**Notification of a Decision taken by the Cabinet Member for
Regeneration, Environment and Housing**

- Proposed VSW1 CPZ Wool Road area – formal consultation.

Subject: Proposed VSW1 CPZ Wool Road area – formal consultation.

Appendix 1 – Drawing No. Z78-345-01 rev A

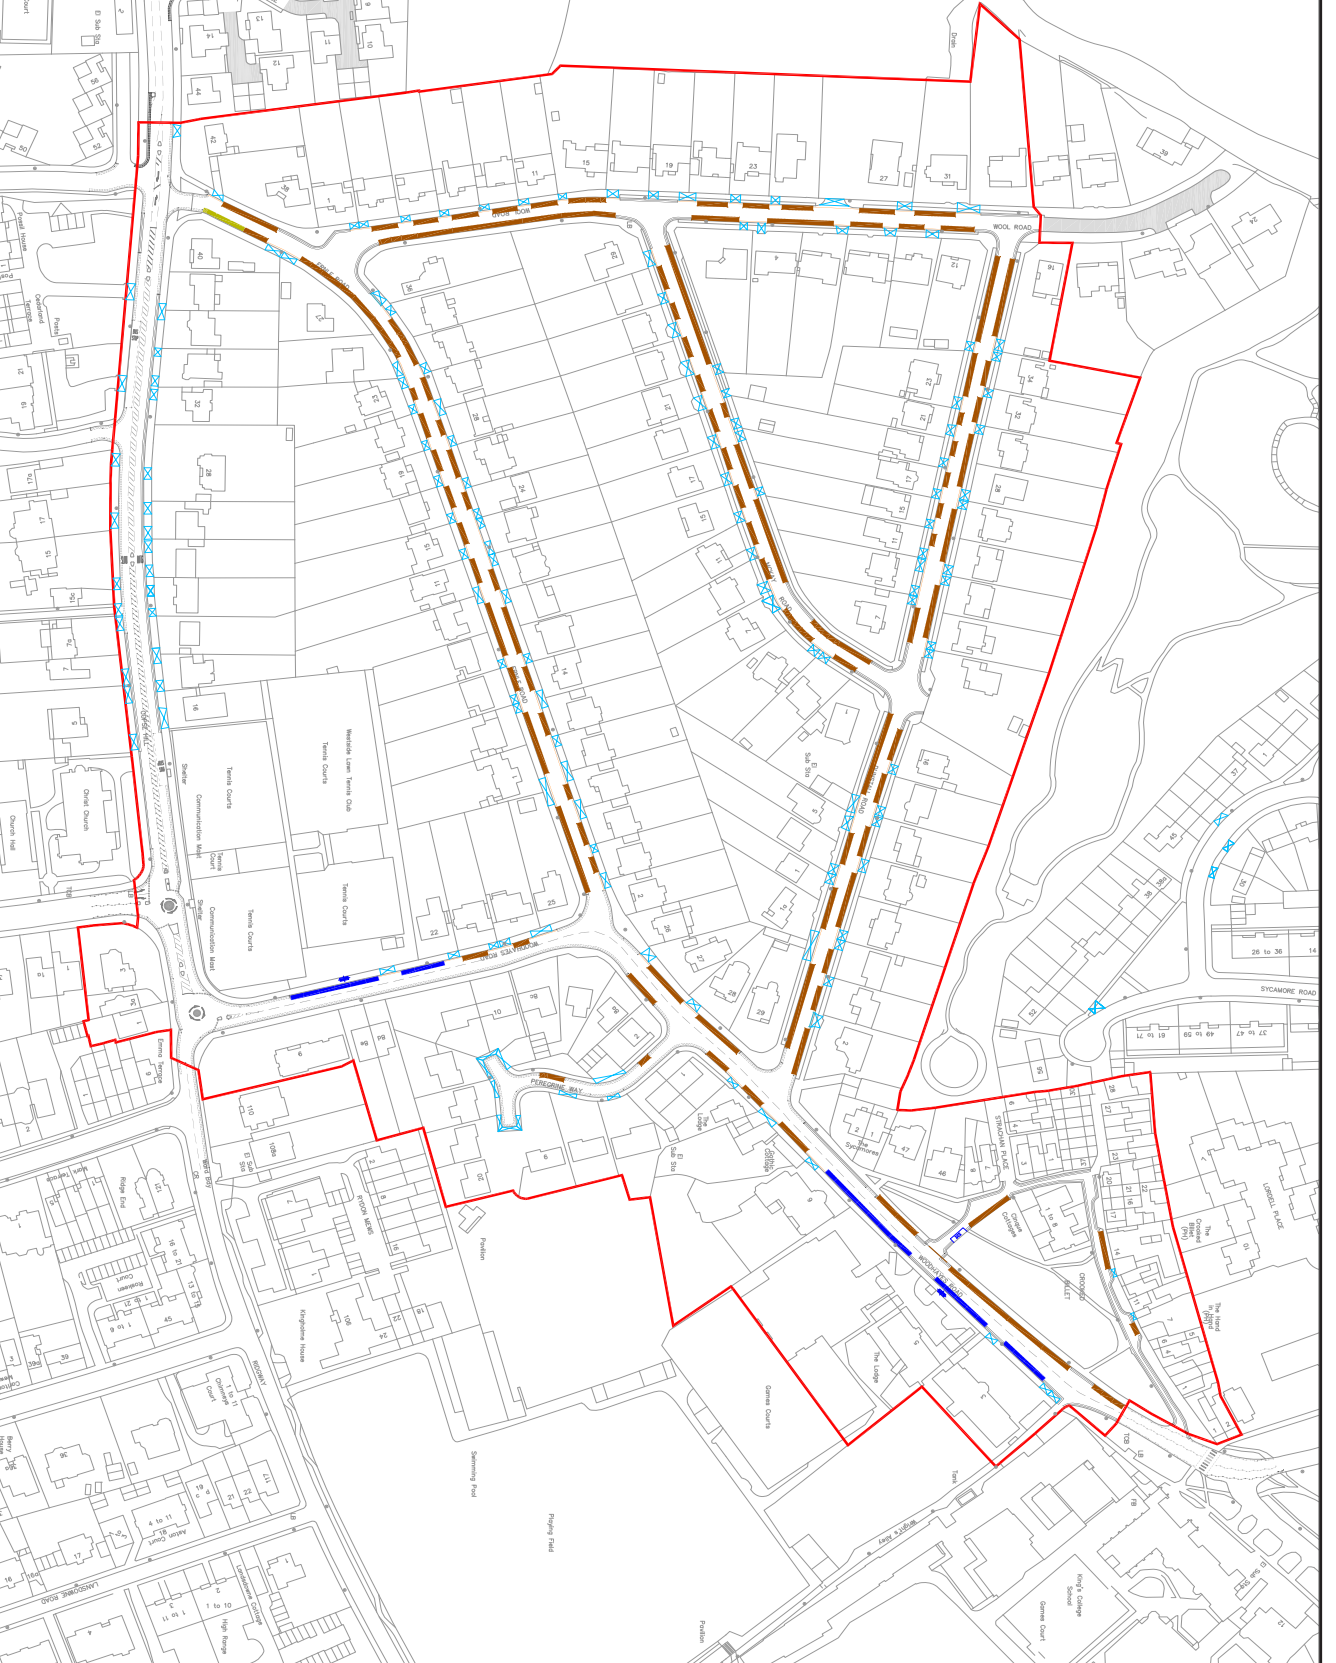
2. I see from the proposed plan than the parking is intended to be permitted on both sides of McKay Road adjacent to No3 and No5. I would encourage your colleagues to see if that is compatible with being able to go in and out of driveways as the roadway is not wide. At the very least there needs to be a restriction on how close cars can park to driveways otherwise there is insufficient room to swing in or out - especially when moving backwards. I would suggest a couple of metres at least.

However, we would question why, with 55 properties in Crooked Billet, only 8 spaces are proposed when at present we are able to comfortably park 16 cars. We are disappointed with the proposed loss of the two spaces by 9 Strachan Place. One maybe but surely not both? And indeed the loss of a further three spaces where the Crooked Billet adjoins Woodhayes Road opposite Kings Sports Hall. Obviously, we need a disabled bay but surely it does not need to take up the whole area which at present is used to park up to three cars?

6. First, not all Woodhayes Rd residents have off-street parking. Your plan of the roads and residences pictures my residence 6 Woodhayes Rd as having an on-site off-street parking space and cross-over. This is UNTRUE. Your plan ignores the existence (since the 1960s) of the two other residences 6a and 6b; I understand that the forecourt in question is associated with 6a, leaving 6b also without contiguous off-street parking.

- 4) I see that, as usual, Merton is proposing to reduce valuable parking capacity by introducing yet more double yellow lines in Woodhayes Road. There is no need to extend the double yellow lines to outside 47 Crooked Billet. Just after the totally unnecessary dropped kerb that your engineer and your traffic wardens are so obsessed about would be sufficient. If the argument is to smooth traffic flow, my response would be that anything that calms the traffic would be useful. In that email, I pointed out that I was informed by the engineer that Merton does not care about the impact of CPZ's on businesses. I had in mind the impact of the CPZ on the pubs (Crooked Billet and Hand in Hand) and the sports clubs (Kings and Westside).

Within a CPZ (during the operational hours of the zone), parking activity is regulated along every inch of kerb space. Yellow lines are proposed where parking must not take place e.g. around junctions, outside schools, at crossovers which give access to properties. The design of the CPZ will remove inconsiderate and obstructive parking from the area.

Within a CPZ (during the operational hours of the zone), parking activity is regulated along every inch of kerb space. Yellow lines are proposed where parking must not take place e.g. around junctions, outside schools, at crossovers which give access to properties. The design of the CPZ will remove inconsiderate and obstructive parking from the area.

The current number of parking bays proposed in the area are believed to be sufficient for residents and their visitors.
